164-170 Croatia Ave, Edmondson Park SSWPP Review Panel RFI Landscape & Public Domain Responses

By: Site Image Landscape Architects

Date : 30 June 2021

SSWPP Review Panel Requests for Information (26 April 2021) -Landscape & Public Domain Responses

Nearmap aerial imagery utilised for vegetation mapping.

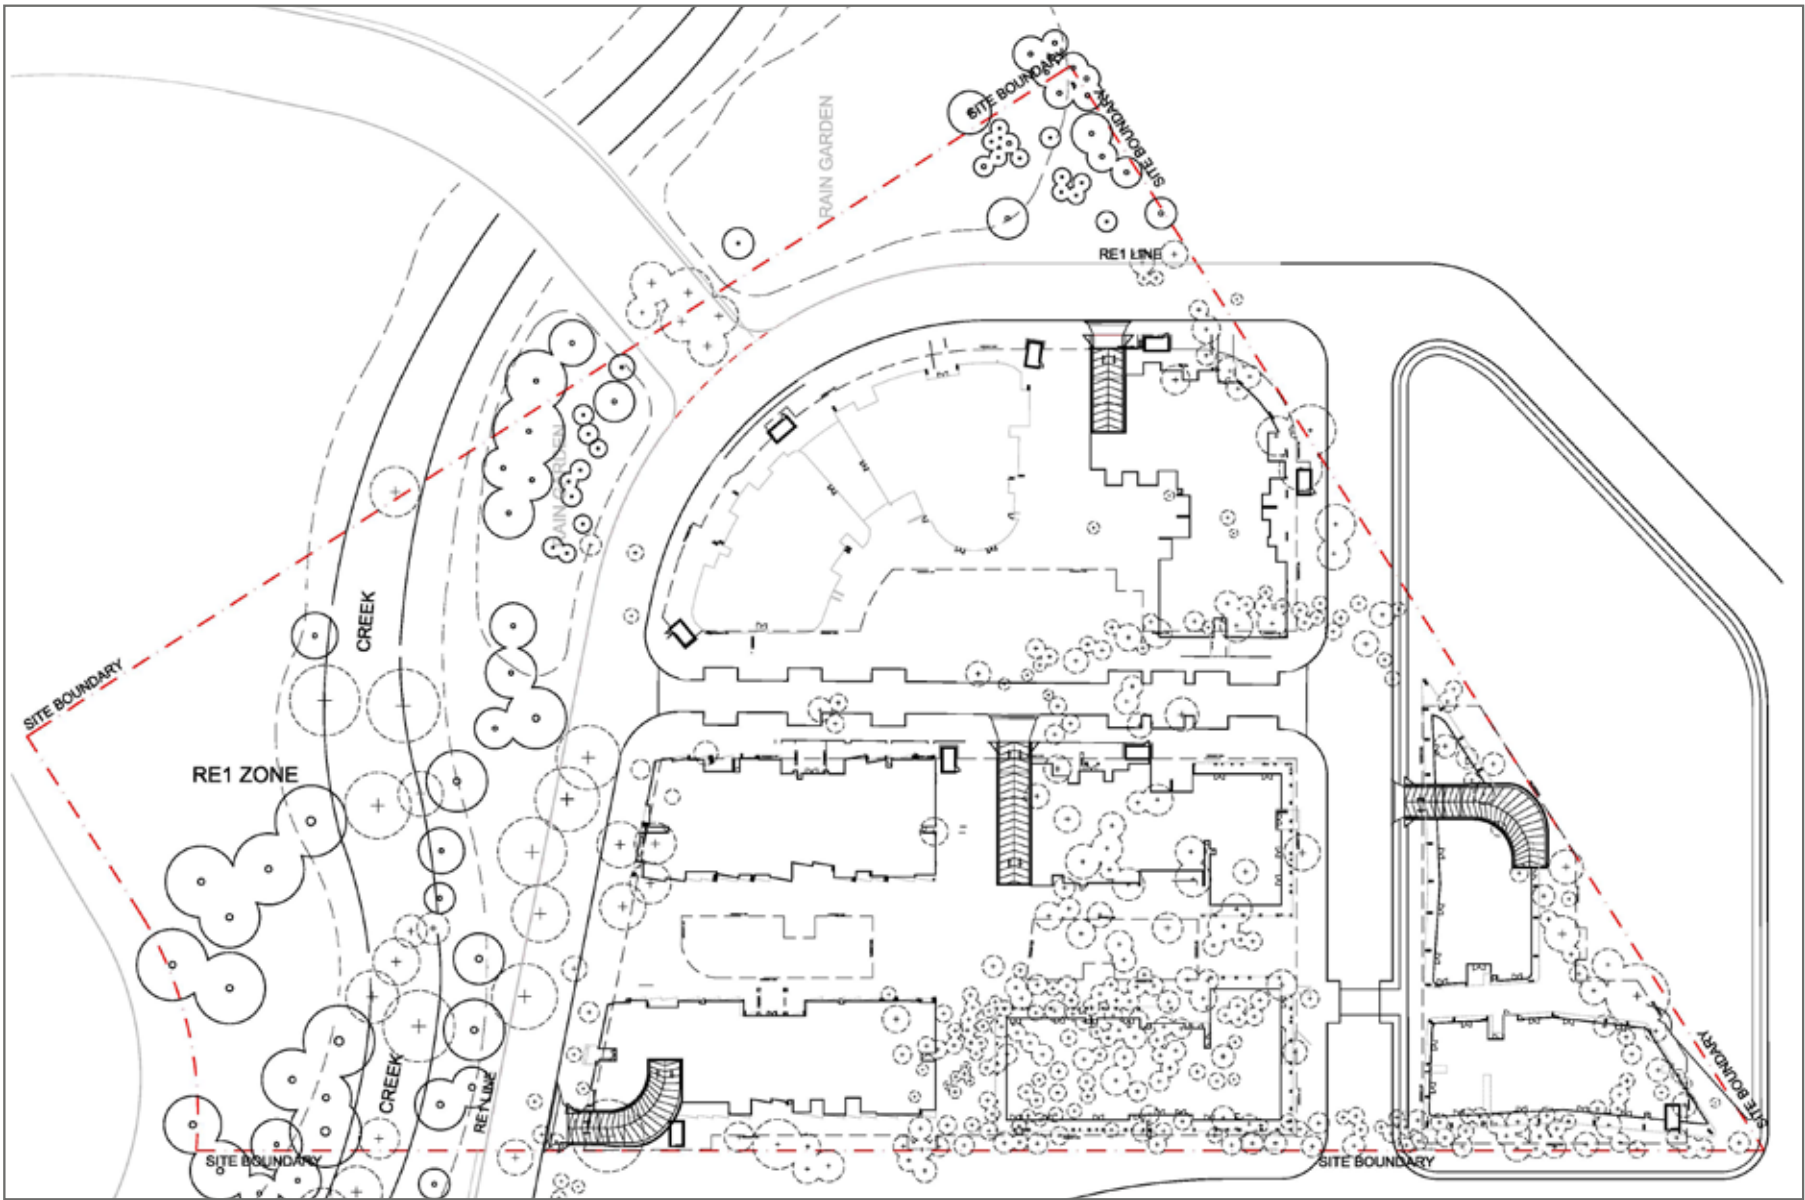
12.5.4 The proposed landscape plans do not identify retention of any existing trees or fauna on site. As a primary control of the ADG, retention of any applicable trees/vegetation should be addressed accordingly. Provide details/reasoning for all existing fauna being compromised as part of the development.

Nearmap aerial imagery provided the base for site vegetation mapping. Regrowth of sapplings is most prominent across the development site, indicating that the site has been ‘recently’ cleared. The most substantial impact on vegetation is due to earthworks and formation of new creekline through the riparian corridor, and formation of the adjacent ring road. Vegetation on the subject site is principally for prescribed infrastructure works, and tree removal on the development site is considered minor and trees would be isolated and offer little habitat /
